UNITED STATES
DEPARTMENT OF THE INTERIOR
BUREAU OF LAND MANAGEMENTFORM APPROVED
OMB NO. 1004-0137
Expires: January 31, 2018**SUNDRY NOTICES AND REPORTS ON WELLS**
Do not use this form for proposals to drill or to re-enter an abandoned well. Use form 3160-3 (APD) for such proposals.5. Lease Serial No.
NMLC062140A

☐ Oil Well ☒ Gas Well ☐ Other8. Well Name and No.
POKER LAKE UNIT 29 BS 705H

XTO Permian Operating, LLC, requests permission to make the following changes to the original APD:

Poker Lake Unit 29 BS 705H
 Projected TD: 19631' MD / 11854' TVD
 SHL: 2310' FNL & 2040' FEL , Section 29, T25S, R31E
 BHL: 200' FSL & 2430' FEL , Section 32, T25S, R31E
 Eddy County, NM

Plan: PERMIT (#705H/OH)

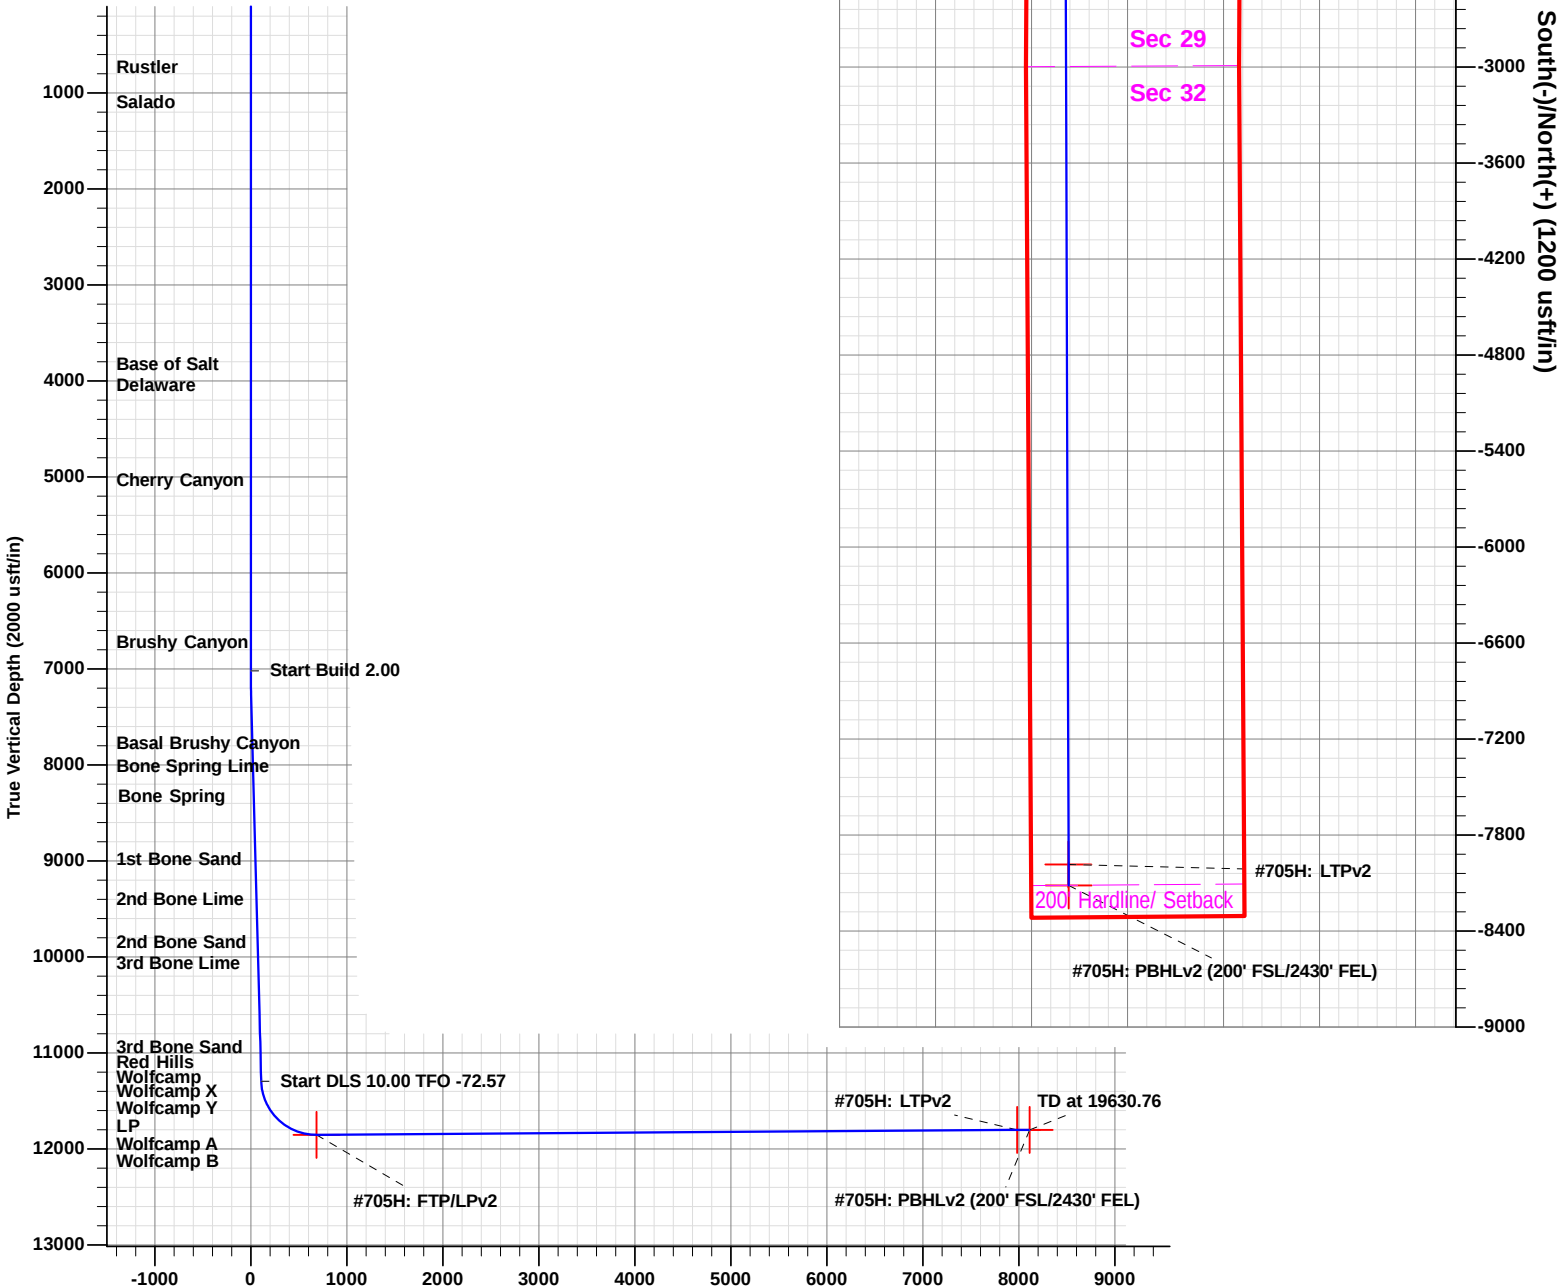
Change BHL from 200'FSL & 2310'FEL in Sec. 5-T26S-R31E to 200'FSL & 2430'FEL in Sec. 32-T25S-R31E.

Wellhead diagram during skidding operations

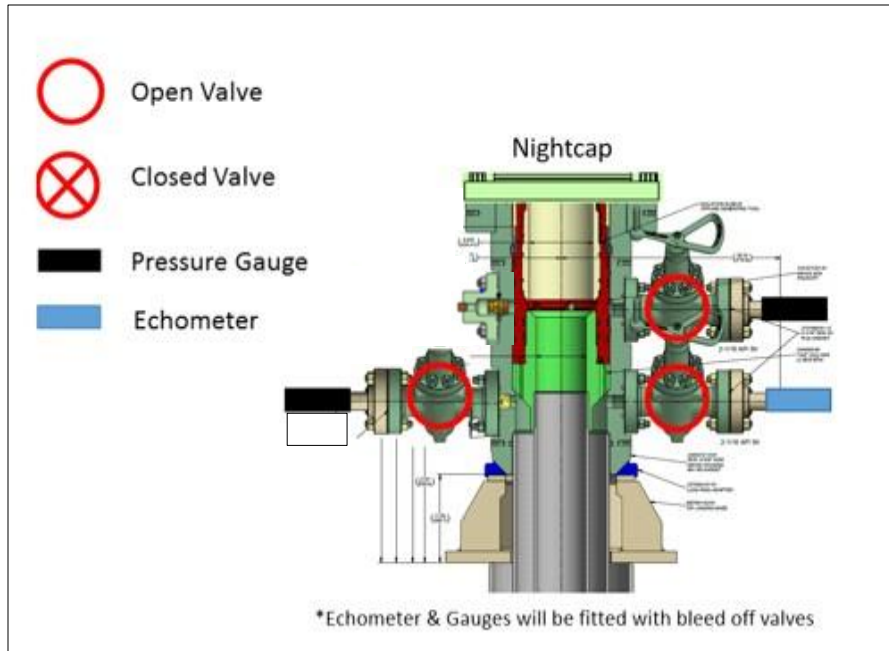
6. Skid rig to next well on pad.
7. Confirm well is static before removing cap flange, flange will not be removed and offline cementing operations will not commence until well is under control. If well is not static, casing outlet valves will provide access to both the casing ID and annulus. Rig or third party pump truck will kill well prior to cementing or nipping up for further remediation.

Wellhead diagram during offline cementing operations

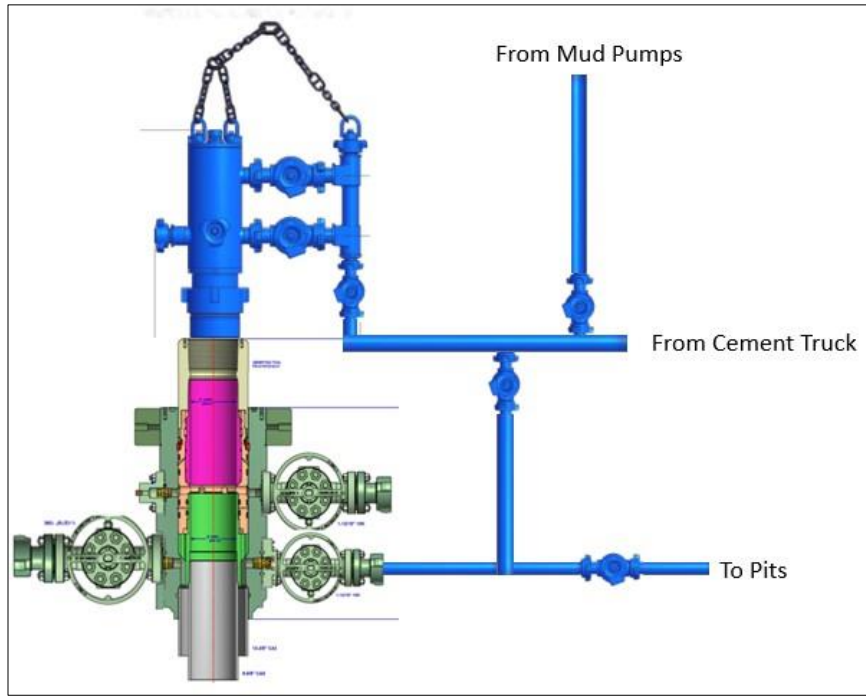
10. Circulate bottoms up with cement truck
 - a. If gas is present on bottoms up, well will be shut in and returns rerouted through gas buster to handle entrained gas
 - b. Max anticipated time before circulating with cement truck is 6 hrs
11. Perform cement job taking returns from the annulus wellhead valve
12. Confirm well is static and floats are holding after cement job
13. Remove cement equipment, offline cement tools and install night cap with pressure gauge for monitoring.
